Consistency assessment report

Proposed changes between Eaton Road, Luddenham
and Littlefields Road, Luddenham

**The Northern Road Upgrade – Mersey Road,
Bringelly to Glenmore Parkway, Glenmore Park**

December 2018

Figure 4-1 Vegetation communities and threatened species

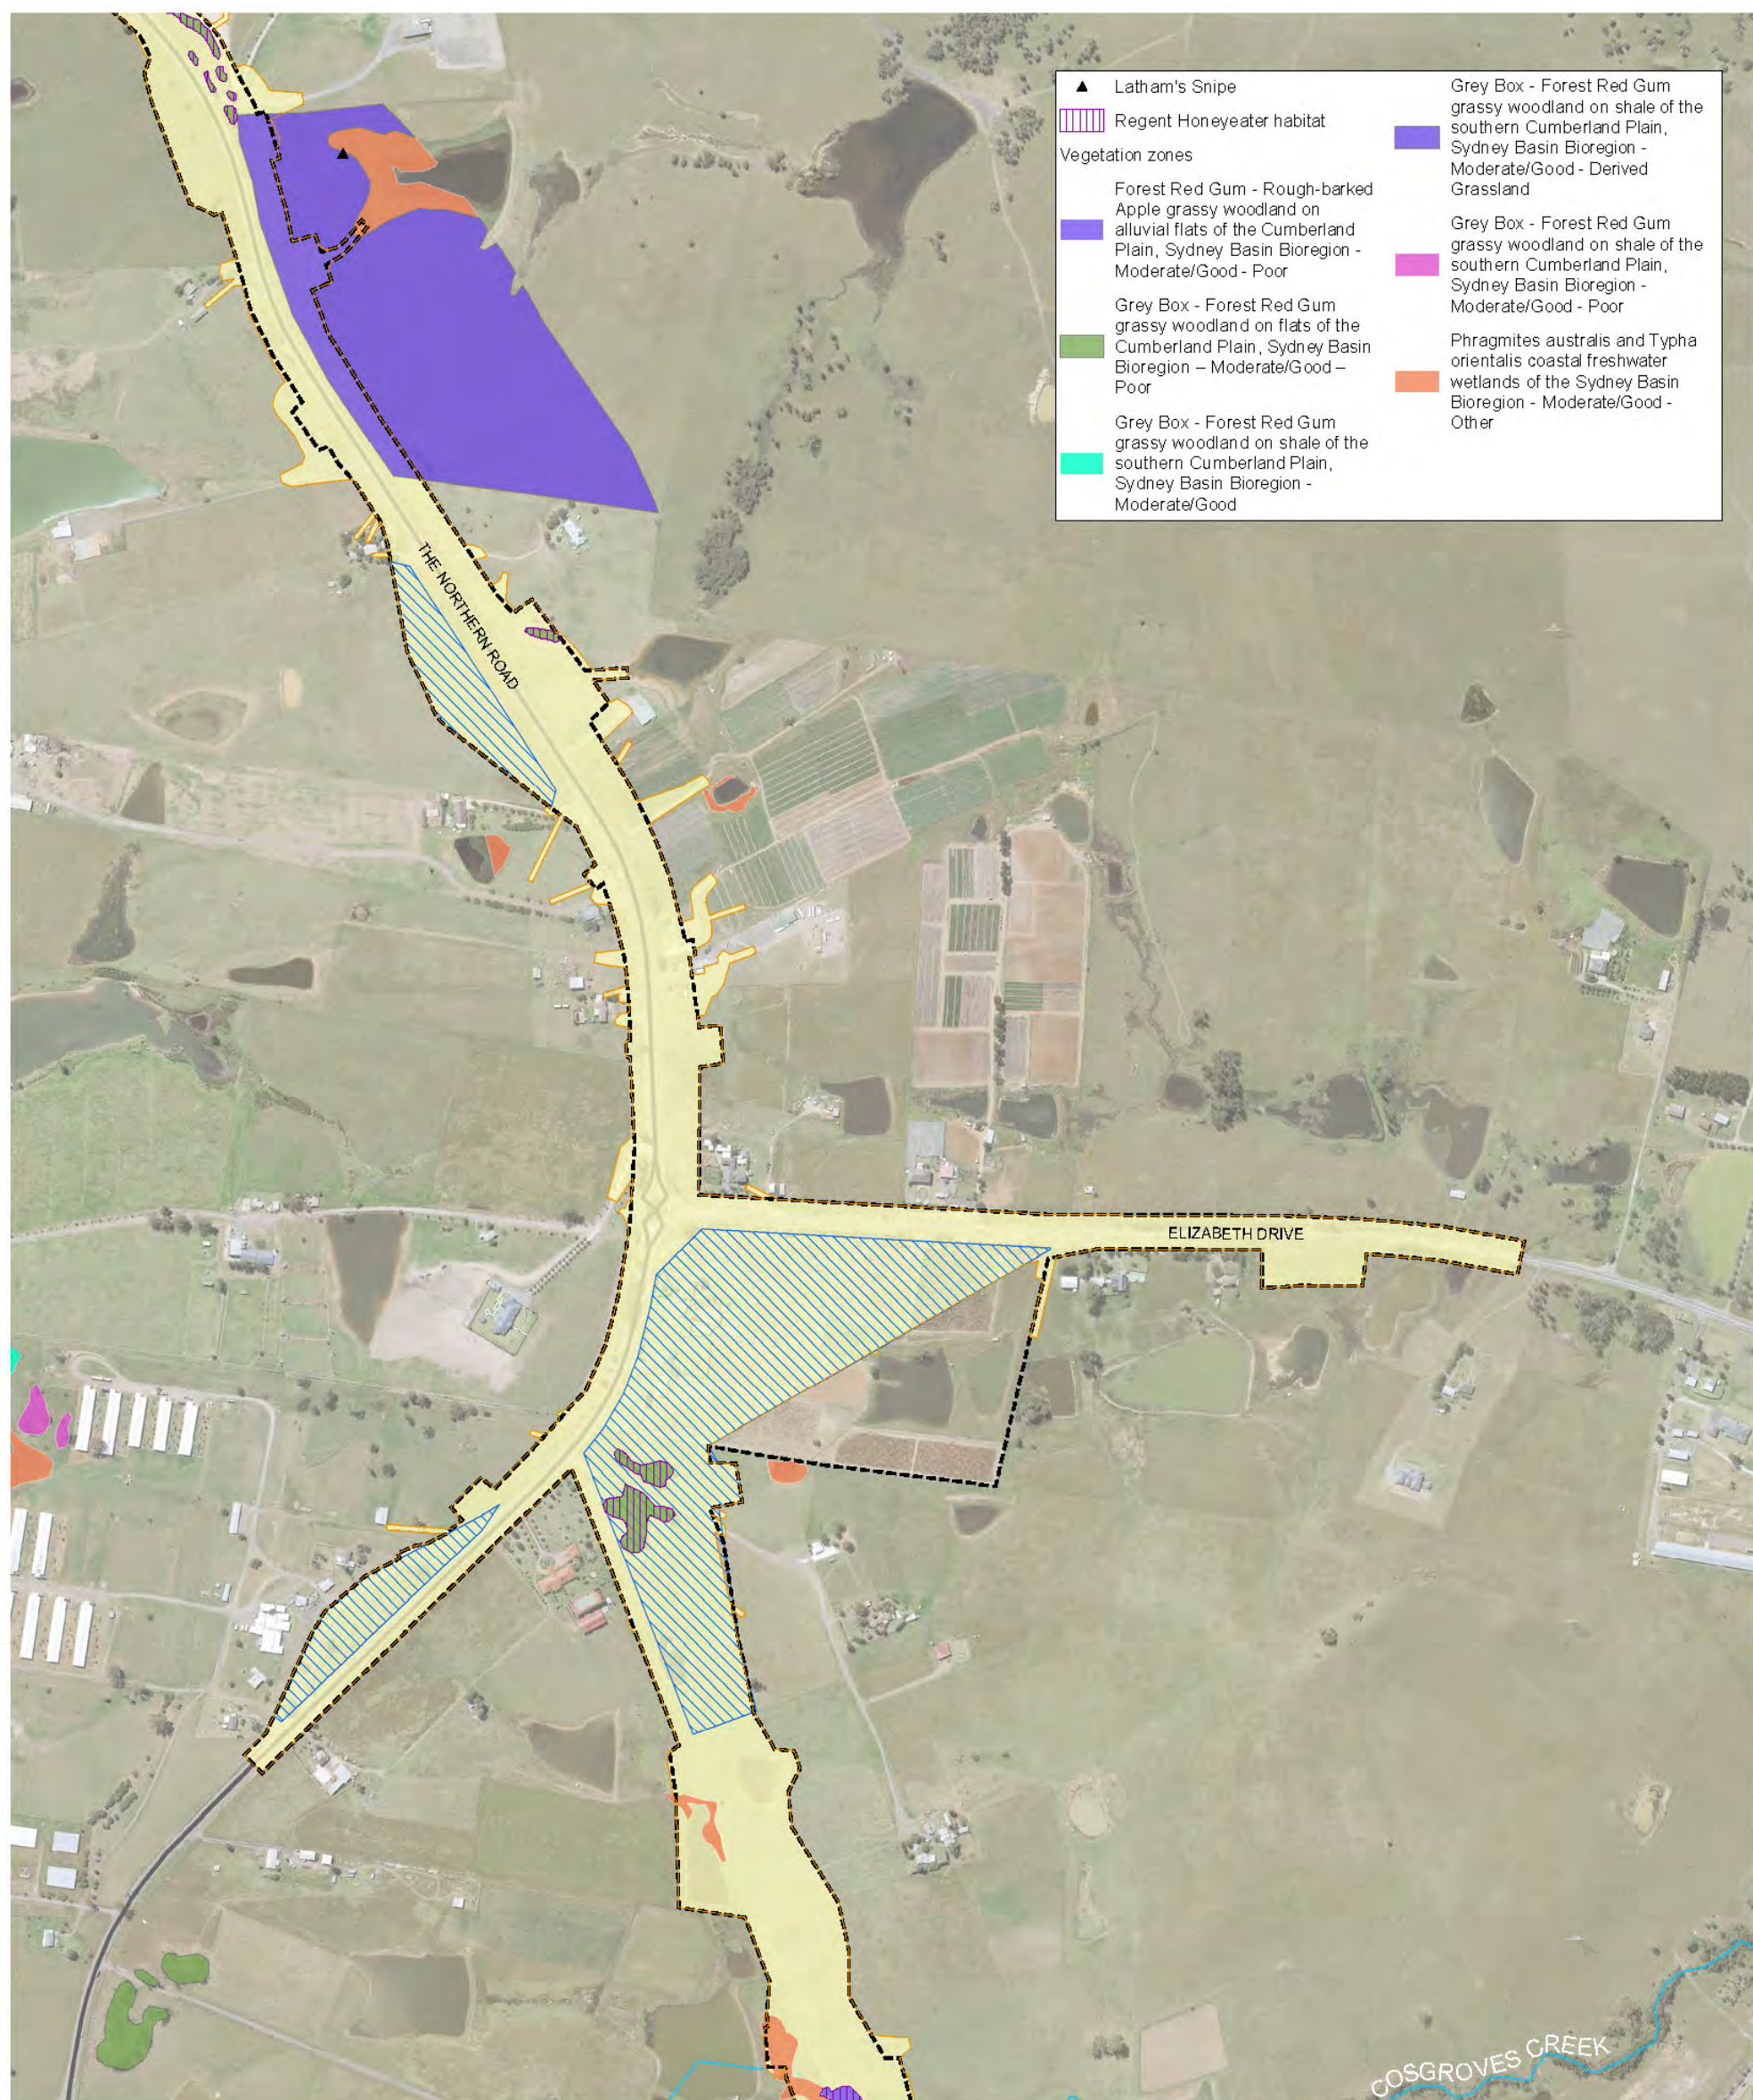
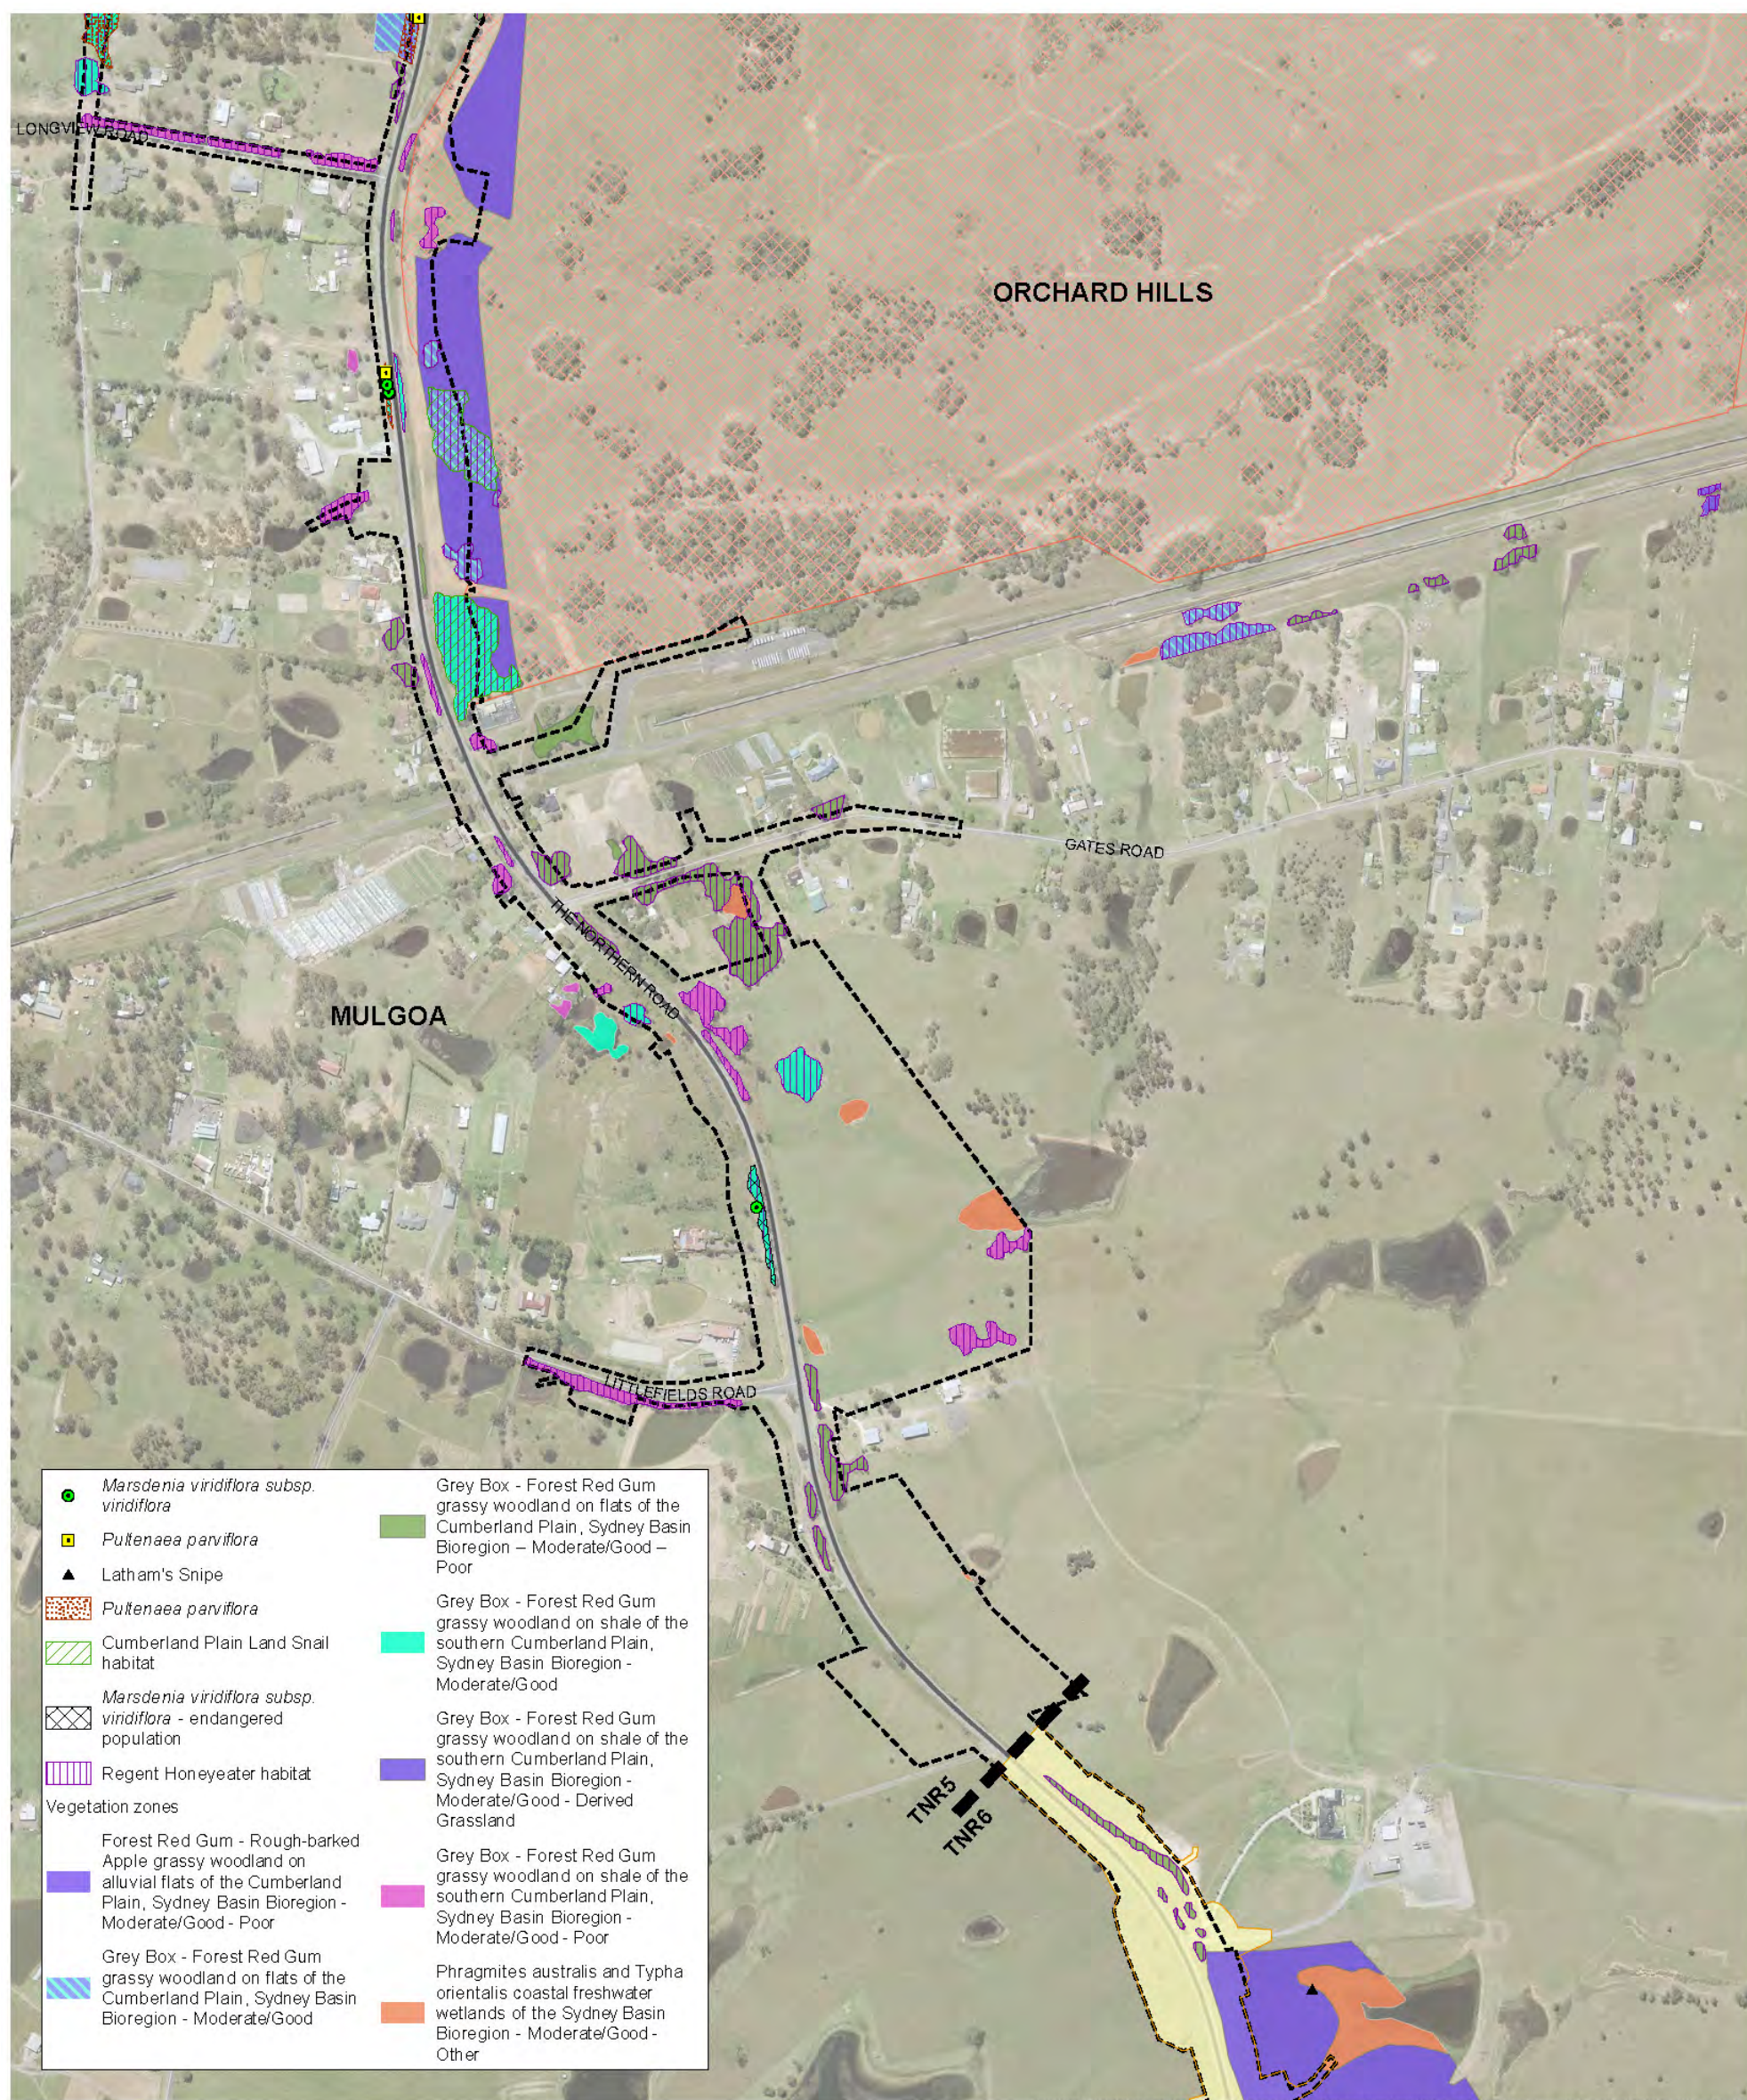
Vegetation communities and threatened species are shown in relation to the proposed project construction footprint in Figure 4-1.

The construction of the proposed intersection at Adams Road requires an additional area of construction footprint. Within this area there are a number of artificial wetlands, specifically farm dams, and a second order intermittent stream. Minor increases to the construction boundary are also required to allow private property access adjustments. Within these areas there are small areas of vegetation grassy woodland. Vegetation zones and plant community types within the proposed additional construction footprint are described in Table 4-3.

- Vegetation Zone 8, the Grey Box – Forest Red Gum grassy woodland on shale of the southern Cumberland Plain, Sydney Basin Bioregion (Derived Native Grassland) (0.03 hectares)
- Vegetation Zone 9, the *Phragmites australis* and *Typha orientalis* coastal freshwater wetlands of the Sydney Basin Bioregion plant community type (0.24 hectares).

The overall impact to the critically endangered Cumberland Plain Woodland in the Sydney Basin Bioregion ecological community has increased slightly by 0.03 hectares due to a small change in the footprint in an area of Derived Native Grassland. This change is not substantial.

Figure 4-2 Proposed construction and operational water quality controls (Swales) Page 2 of 2

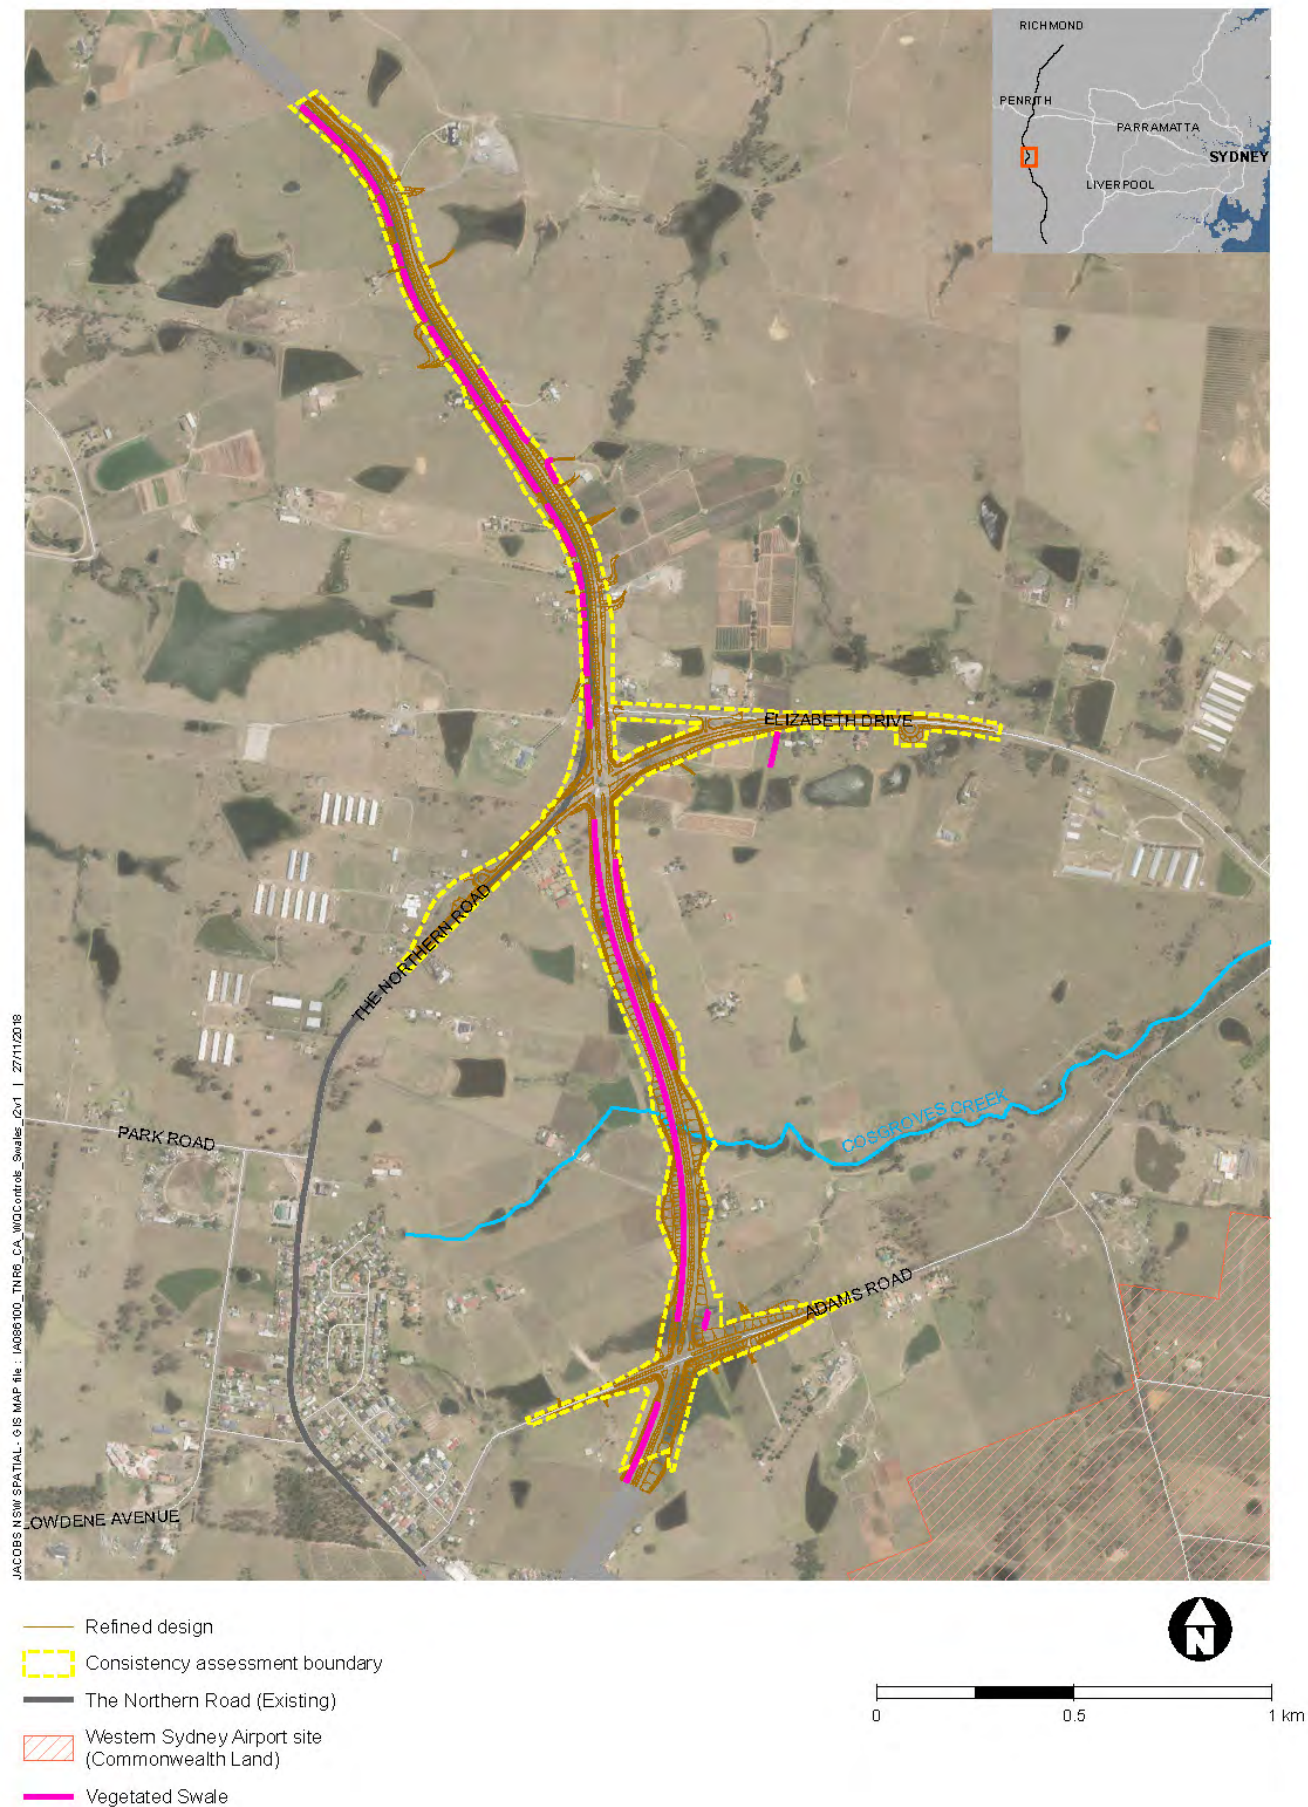
The previous construction drainage design assessed in the EIS, SPIR and Final EIS featured 13 sediment basins along the alignment. The current design features 22 basins covering 37 hectares of disturbed catchment area during the construction stage. The updated design also specifically includes an Erosion and Sedimentation Management Report and set of Plans to address issues regarding erosion and sedimentation during the construction stage, with local control locations proposed in areas that sediment basins cannot be feasibly included due to terrain constraints. The

The current operational drainage design proposed comprises 48 water quality controls (37 vegetated swales and 11 vegetated batter buffer areas) treating approximately 27.1 hectares of disturbed catchment area. The vegetated batter buffer controls have been utilised since changes to pavement drainage in various areas along the alignment has increased sheet flow runoff and decreased the effectiveness of swales.

A comparison of the total lengths of swales and catchment areas for the SPIR and Final EIS design and the current proposed drainage design is provided in Table 4-7. The revised design water quality control measures are shown in Figure 4-2.

The results indicate that the revised road geometry and drainage design would deliver a slight increase in water quality treatment effectiveness compared to that which was previously achieved by the SPIR and Final EIS design.
